Amendments to March 17, 2015 Project Description – April 9, 2015

Responses to CCC questions of April 6, 2015 regarding Drakes Estero Restoration Project.

Supplemental Appendix 1

TITLE OF SHEET
FIGURE 12 STAGING AREA (CONCEPTUAL)
PRELIMINARY ENGINEERING REPORT DBOC DEMOLITION
AND REMOVAL OF IN-WATER INFRASTRUCTURE
DATE:
2/2015

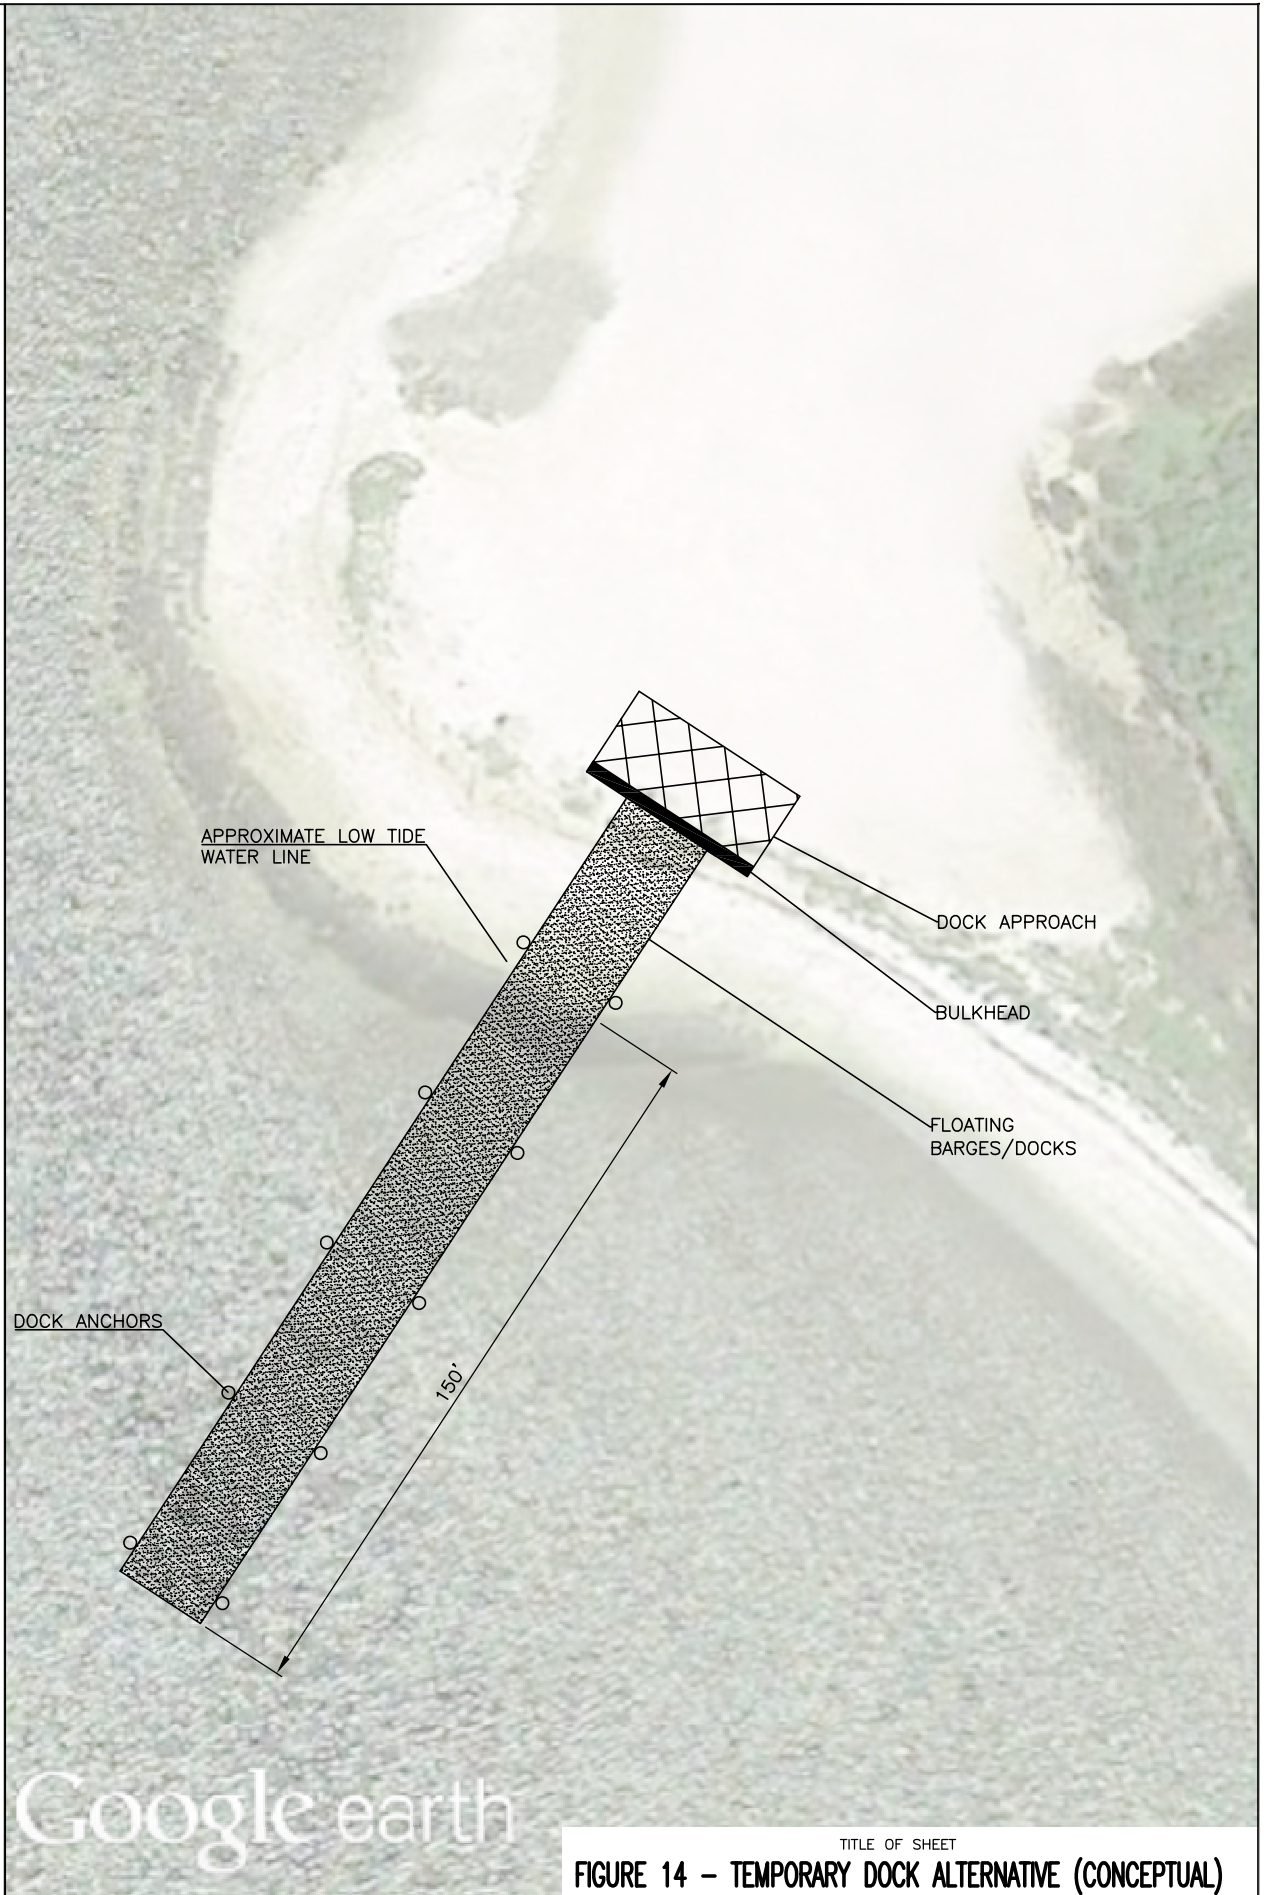
11) The location and type of onshore structures (lighting, parking, restrooms, temporary offices, etc.) that would be installed at the onshore base of operations.

The temporary onshore staging site development plan is attached (Figure 12 of the Title I report). Based on discussions with the design engineer, the onshore area will not require a shell washing station and other onshore separation and preparation areas. This conceptual plan is not final or to scale but represents the general location and distribution for the work site facilities that will be in operation for the duration of the work period.
